REMARKS

This Amendment is in response to the Office Action dated 01/12/2005. By said Office Action, Claims 1, 2, 4, 9 were rejected and the Specification was objected to under 35 U.S.C. 112, first paragraph, as failing to comply with the enablement requirement. More specifically, the variables A_i , B_i , D_i , E_i and e_i in the claims were indicated as not defined in the claims or the specification. Further in Claim 4, the term "a known power level" was indicated as not defined in the specification. No art was applied to Claims 1, 2, 4 and 9.

AMENDED REPLACEMENT DRAWING SHEET FOR FIG. 8
SN. 10/652,366

FIG. 8

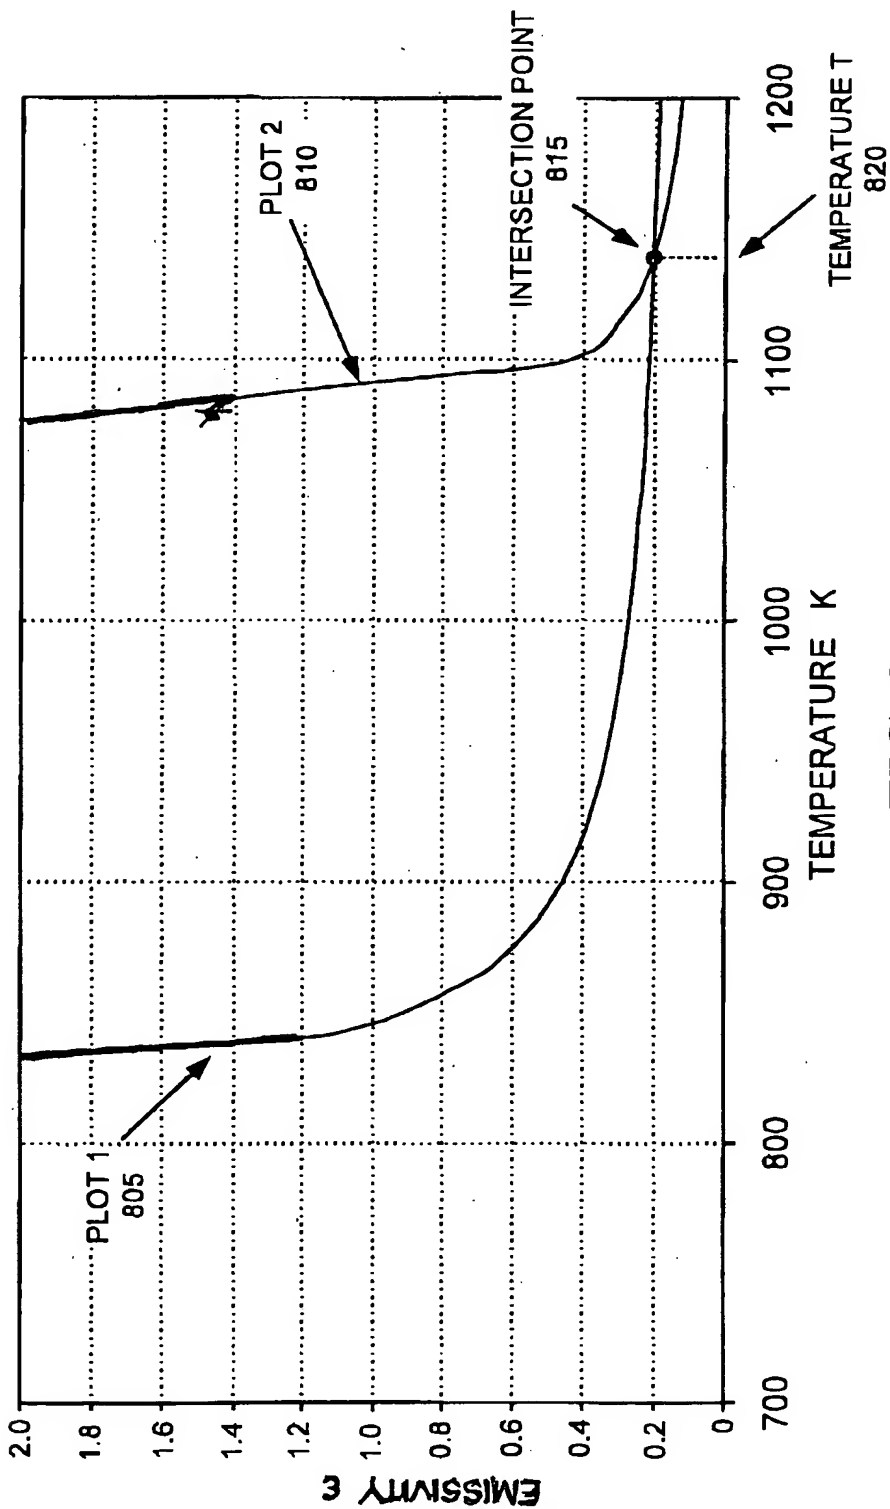
A new Abstract containing between 50 to 150 words was required. The drawings were objected to because Fig. 8 and Fig. 9 do not contain measurement units for the Y-axis.

Marked-Up and Amended replacement FIG. 8 and FIG. 9 are submitted herewith. As noted in paragraph [0013], FIG. 8 is a plot of emissivity versus temperature; and as noted in paragraph [0014], FIG. 9 is a plot of normalized ratios of measured power to calculated emitted power as a function of temperature. The Y-axis of the replacement drawings have been labeled "Emissivity" and "Measured/Calculated Emitted Power ($\frac{A_i}{e_i B_i(T)}$)" (See Eqn. 15 in paragraph [0028]) in FIG. 8 and FIG.9, respectively. Applicant respectfully submits that FIGS. 8 and 9 now comply with the Examiner's requirement.
